**MODIFICATION REQUEST APPLICATIONS FOR CONCEPT PLAN  
MP09\_0216 AND PROJECT APPLICATION MP09\_219 Shepherds Bay  
Redevelopment - Response to Submissions**

# Shepherds Bay

Response to Submissions - modification request  
for Concept Plan MP 09\_216 and Project  
Application MP09\_219  
Submission from City of Ryde Council

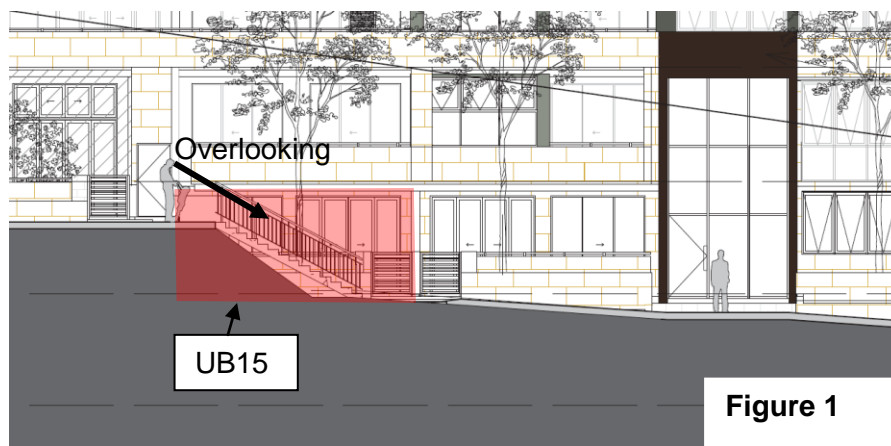
In particular, the RFDC recommends offsetting the floor level of the apartment to provide privacy for residents and to improve the outlook on the street. The proposed use of planting in this situation worsen the minimal solar access of these units creates issues with overlooking into the units from the foreshore link. This problem is significant for UB15 which will adjoin a stairway in the link. This is shown in **Figure 1**.

**UB-15** – For a ground floor unit, this unit is provided minimal open space areas with the planter box not a usable space. The access for the unit from the foreshore link is provided through the bedrooms, likely to experience minimal use and severely compromising the amenity of the bedrooms. It also has not been detailed how security or access to the balcony area from the foreshore link will be controlled. Furthermore, as identified previously, the proximity of this unit to the staircase is of significant concern with regards to overlooking and privacy. The amenity of this unit is minimal and is not supported.
